2023/PDP-1 (MAK)

SUBJECT: Application for an Interim Planned Development-Transit
(IPD-T) Permit - File No. 2023/PDP-1
Project: Chinatown Hotel Development
Landowners: Yee Hop Realty Limited, and
C.Q. Yee Hop & Company Limited
Applicant: Ikenakea Hokele LLC
Agent: Patrick Seguirant
Location: 128 North Nimitz Highway - Chinatown
Tax Map Keys: 1-7-002: 013, 023, and 050
Acceptance Date: October 26, 2023

DEPARTMENT OF PLANNING AND PERMITTING
OF THE CITY AND COUNTY OF HONOLULU

EXHIBIT C-11

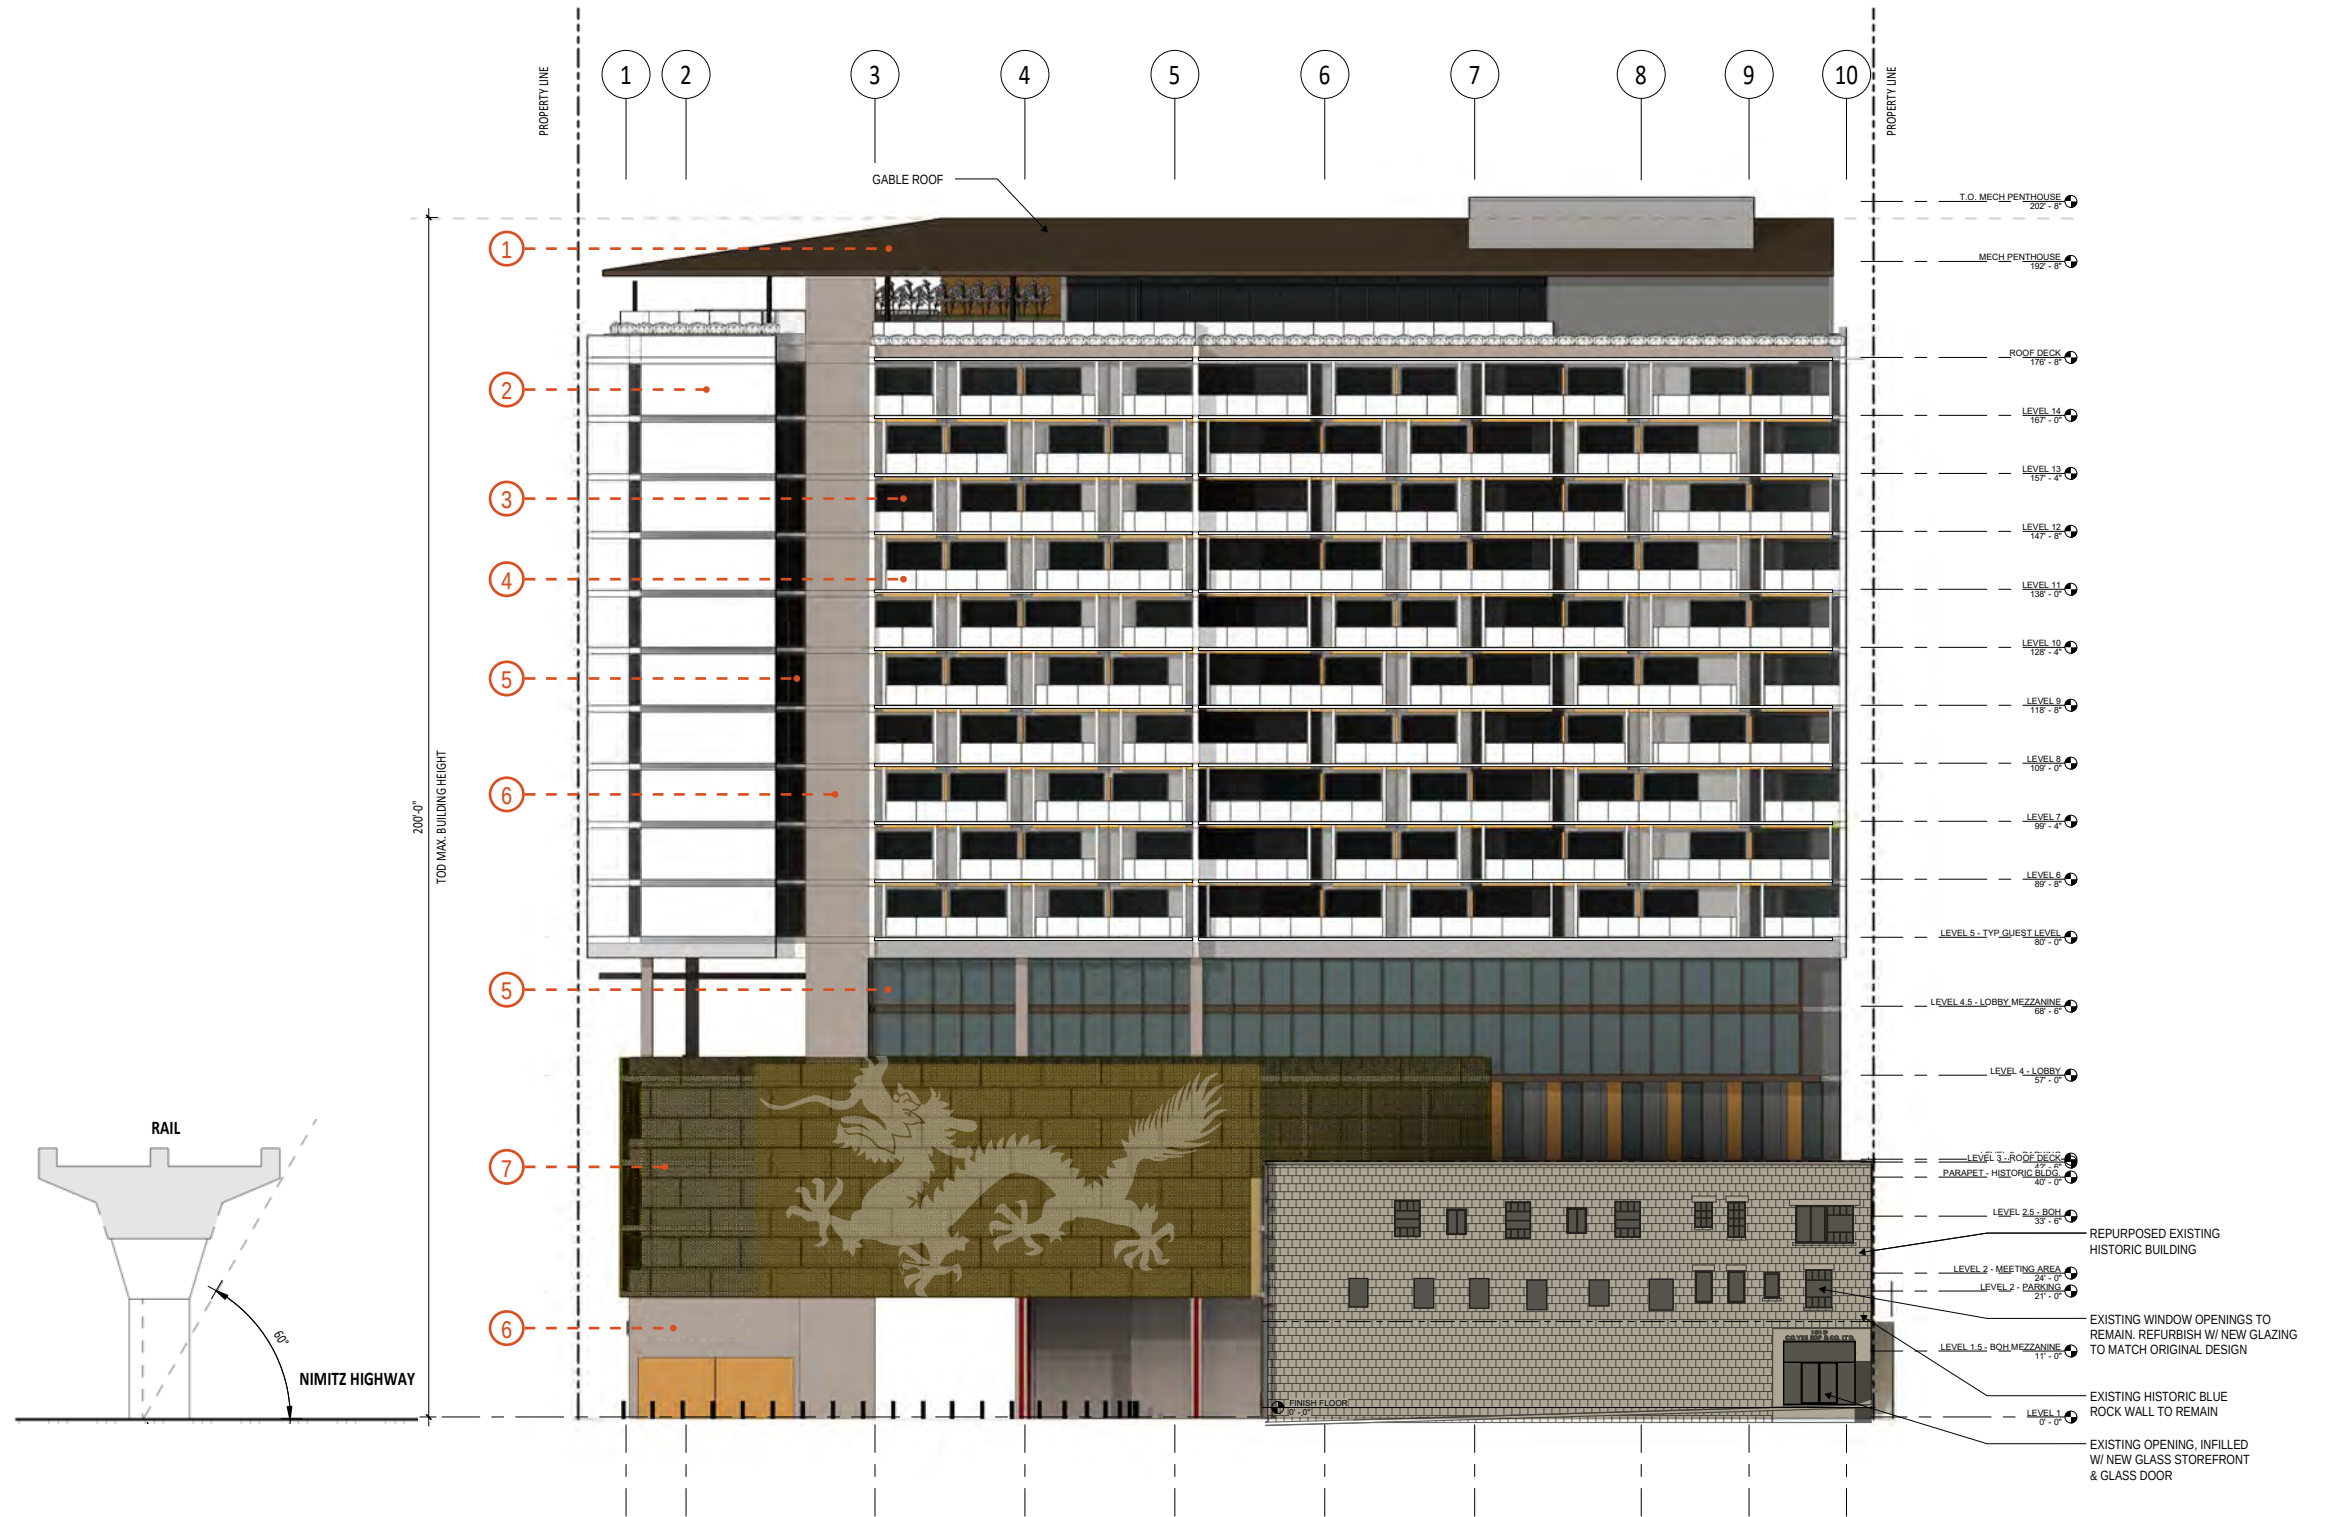
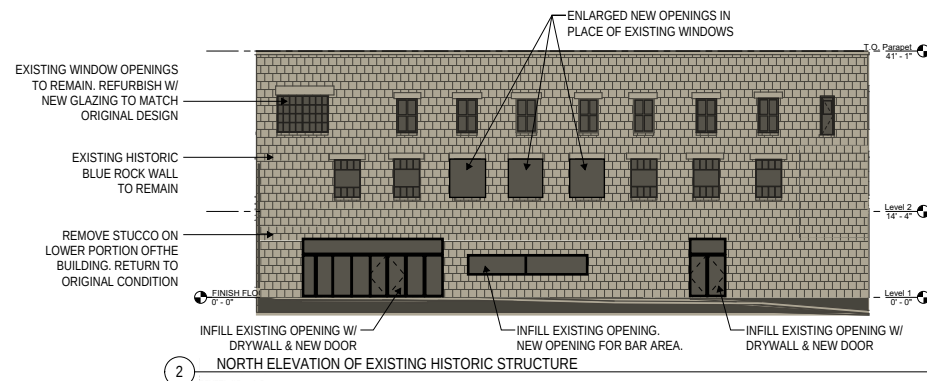
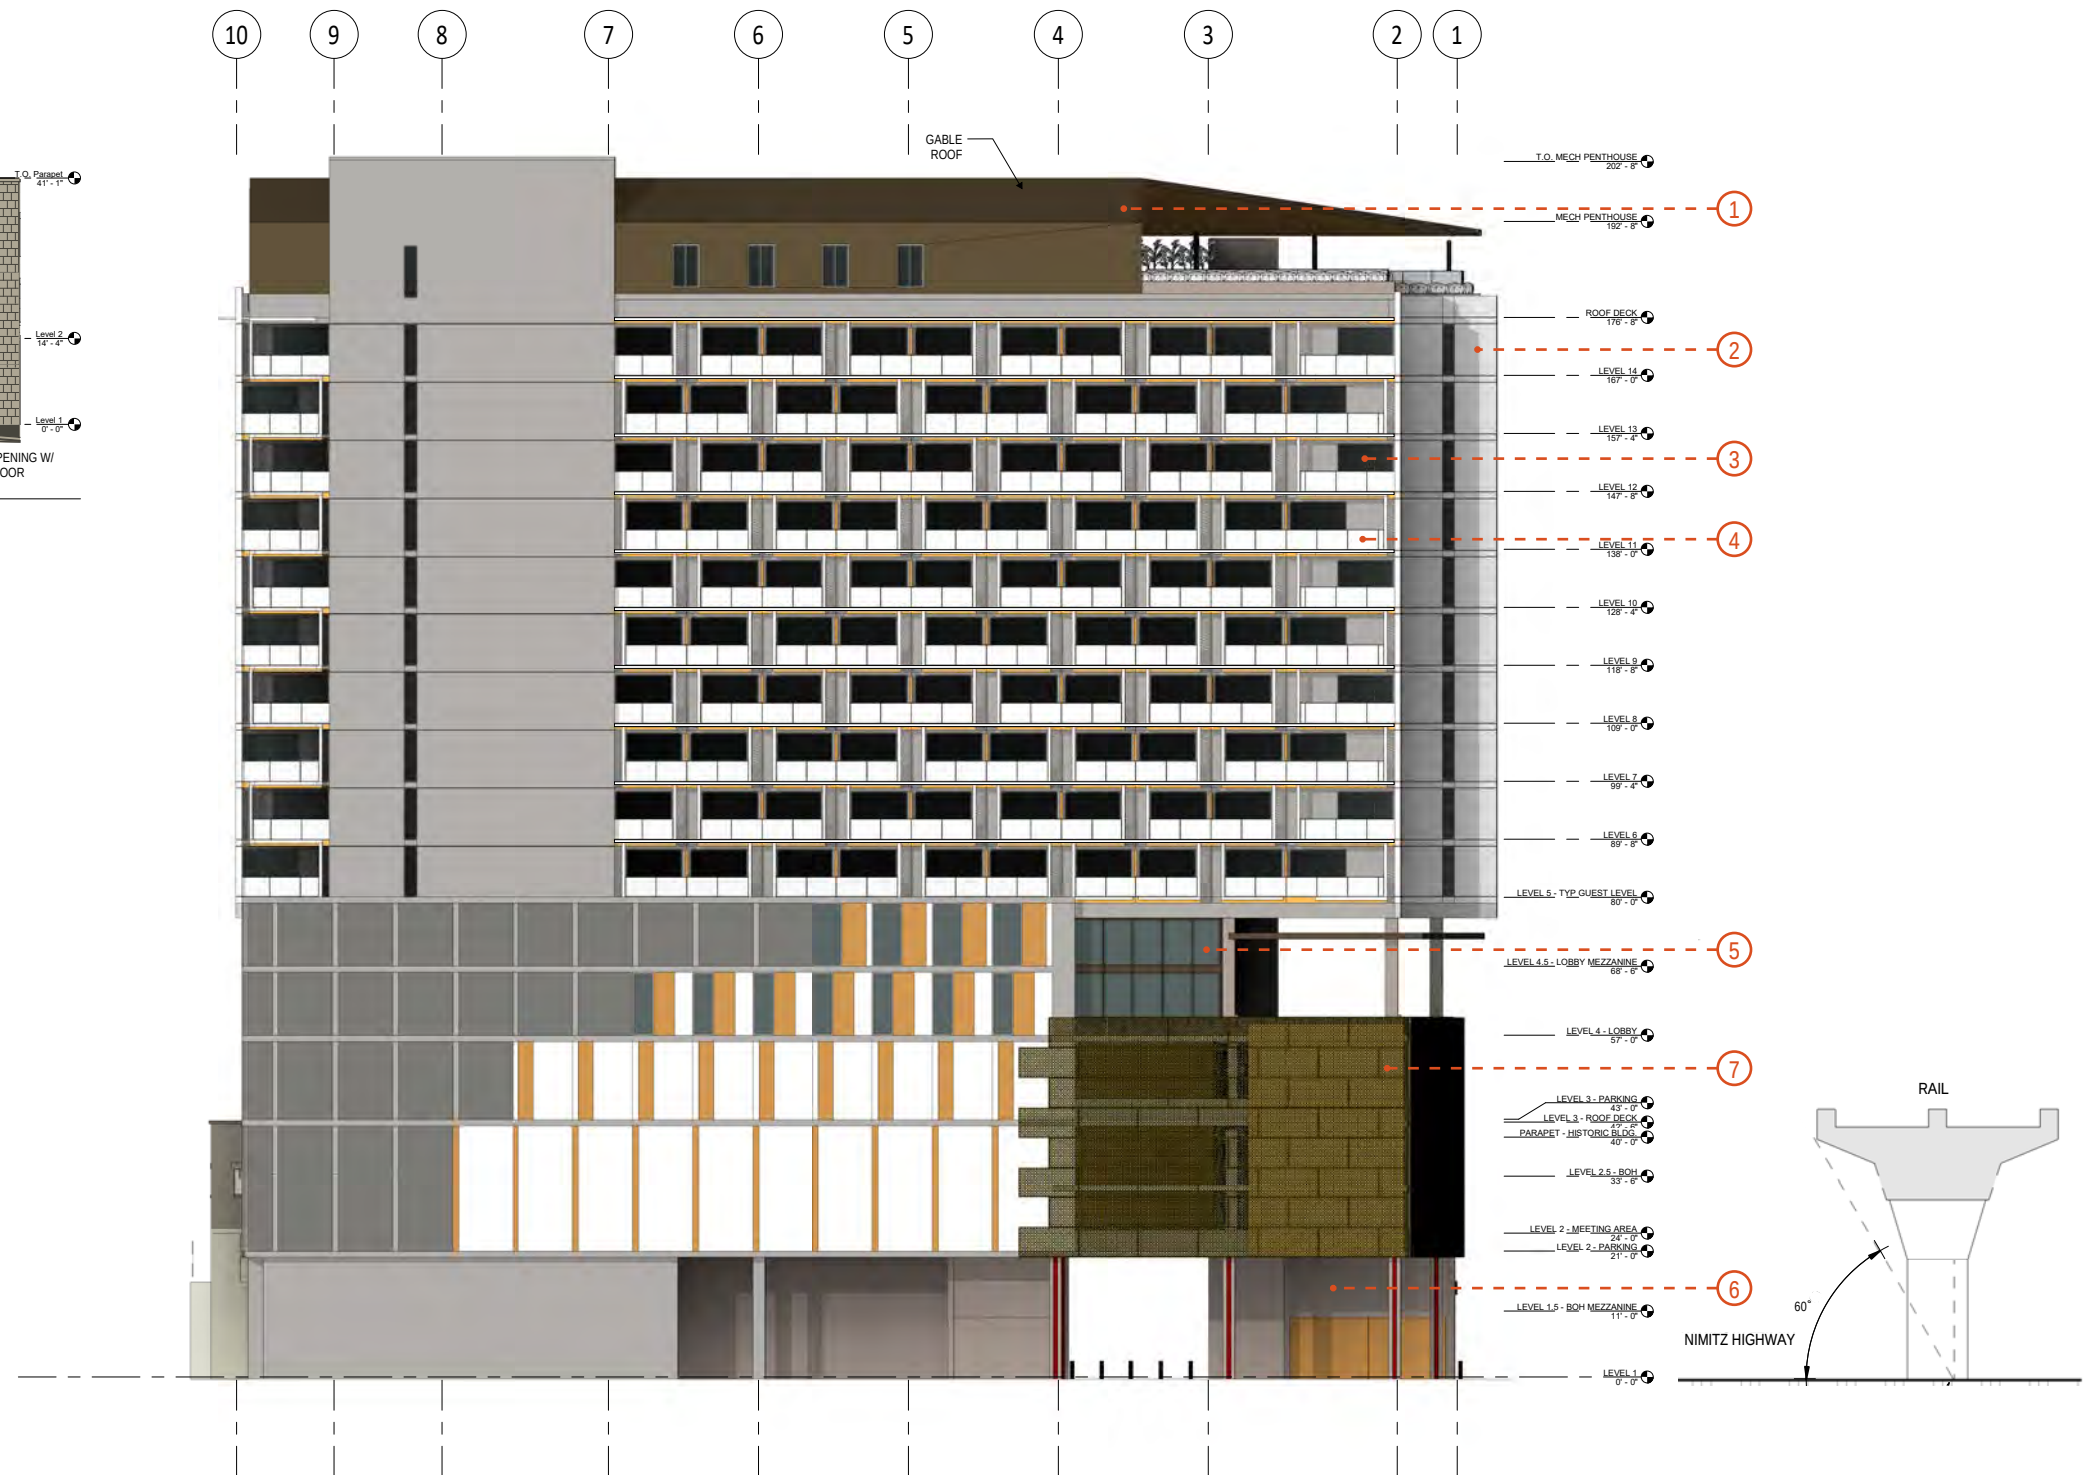
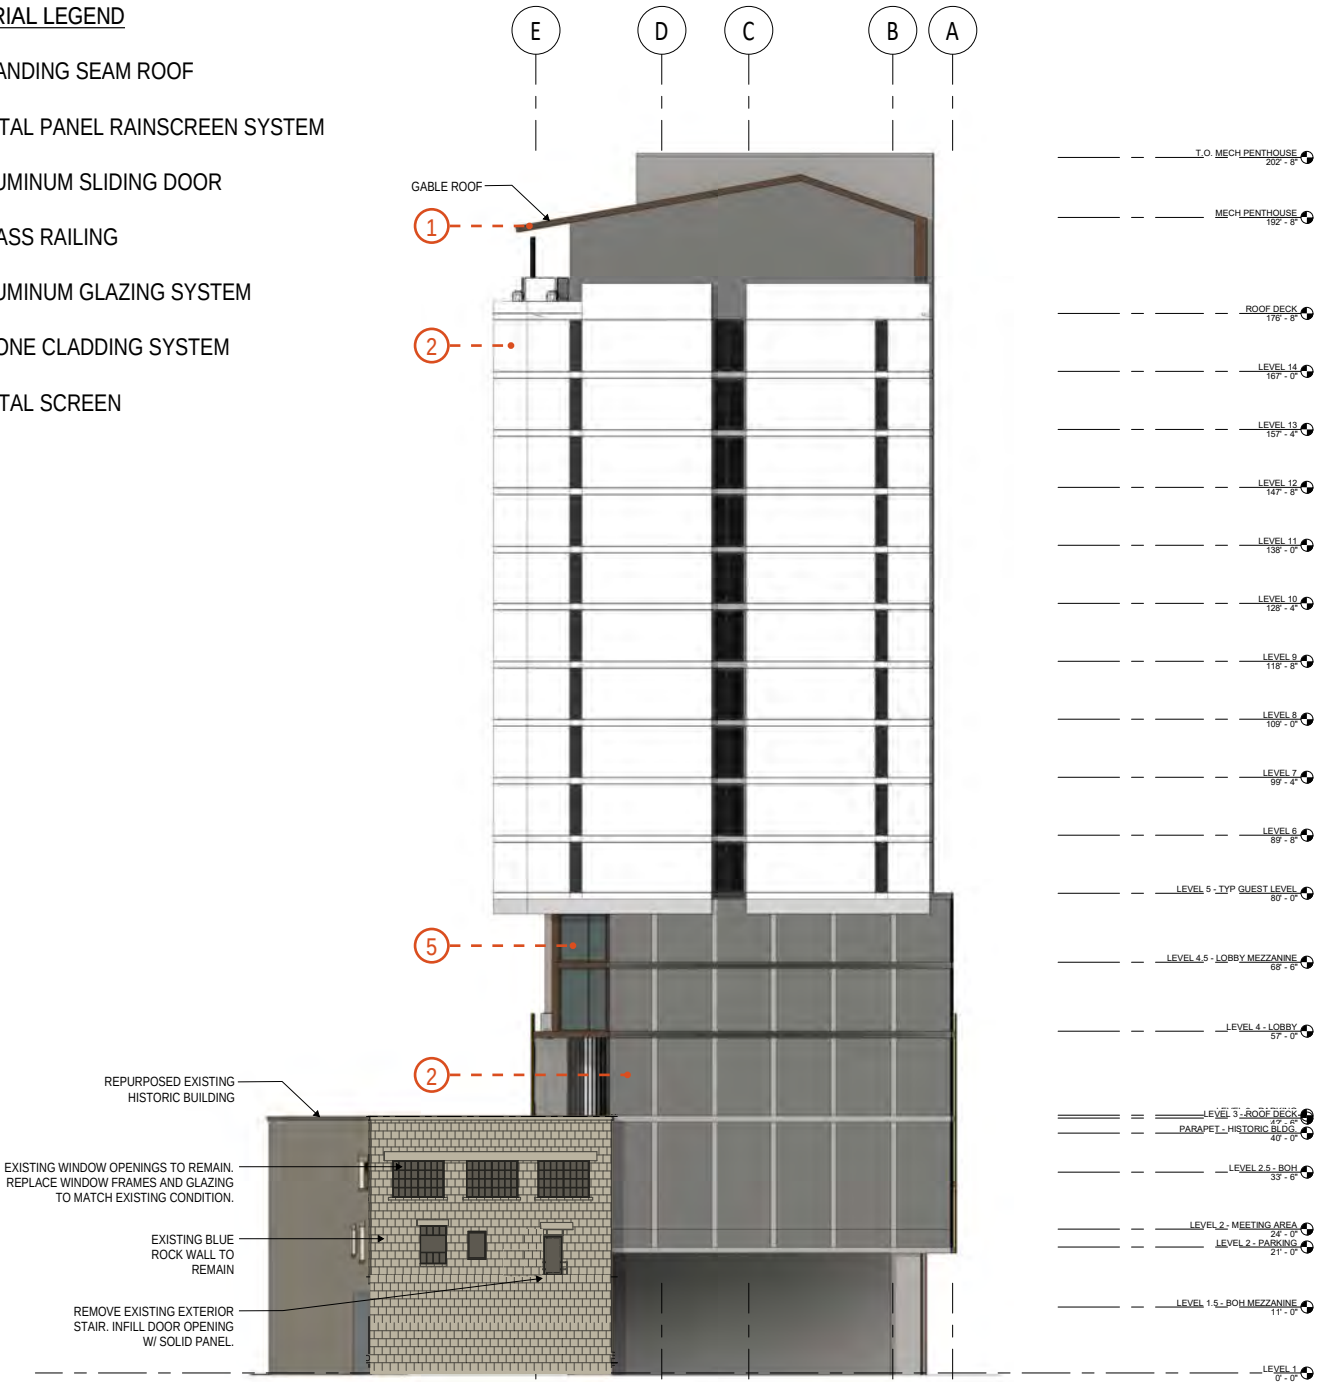
2. Maximum Height: Under the LUO and zoning maps, the maximum height limit for the site is 80 ft. The TOD Plan allows for a maximum height limit of 200 ft. for the site. Through the IPD-T Permit, the Applicant seeks to exceed the height limit by 120 ft. for the full allowance of 200 ft. The IPD-T provisions allow for this increased height if commensurate community benefits are provided to obtain the bonus. The Project proposes a 15-story tower where a five-story tower would otherwise be allowed. If the Project is approved as proposed, the bonus height will result in approximately 10 additional floors and approximately 125,667 sq. ft. of floor area above the height limit (see Exhibits C-11 through C-13). This will be further analyzed below.
